WINNTEC Model #6020 LP REGULATOR

Bulletin Type:	RCL	Publication Date:	November 2021 Revised December 2021
Bulletin #(s):	21V-685 US 2021-562 Canadian	Make(s):	Jayco
Job Code(s):	9901570A - Inspection Only 9901570B - Inspection, Complete Replace, LP Leak Test	Model(s):	Various Models
Flat Rate(s):	9901570A - .10 hr 9901570B - .50 hr	Model Year(s):	2017-2022

INSPECTION OF WINNTEC MODEL #6020 LP REGULATOR

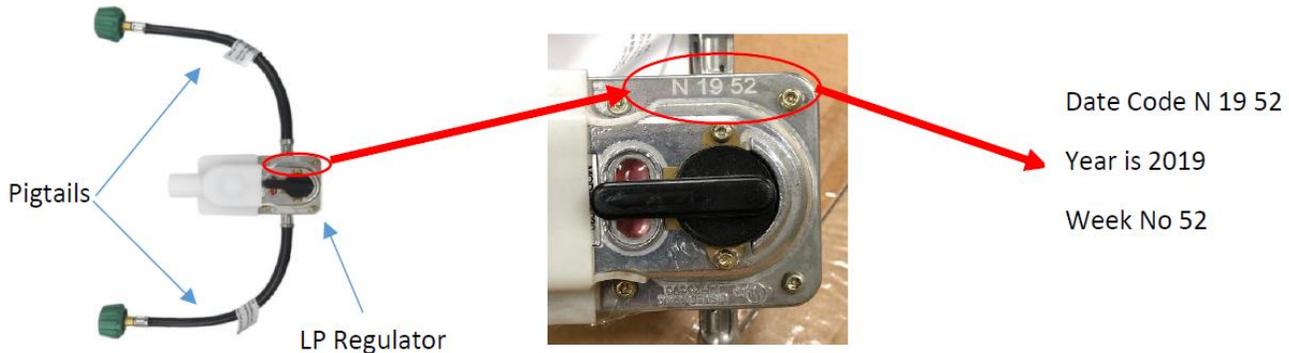
1. Only the Winntec Model #6020 - Dual Stage Double Cylinder - Automatic Changeover Regulator with Pigtails is affected. Replace the regulator and pigtails if the manufacturing date code stamped into the regulator is 18 XX, 19 XX or 20 XX. Example shown below.

2. File a claim for inspection only if the unit does not have a Winntec model #6020 LP regulator or if the date code stamped into the regulator is not 18 XX, 19 XX or 20 XX. Only replace regulators with date codes 18 XX, 19 XX and 20 XX.
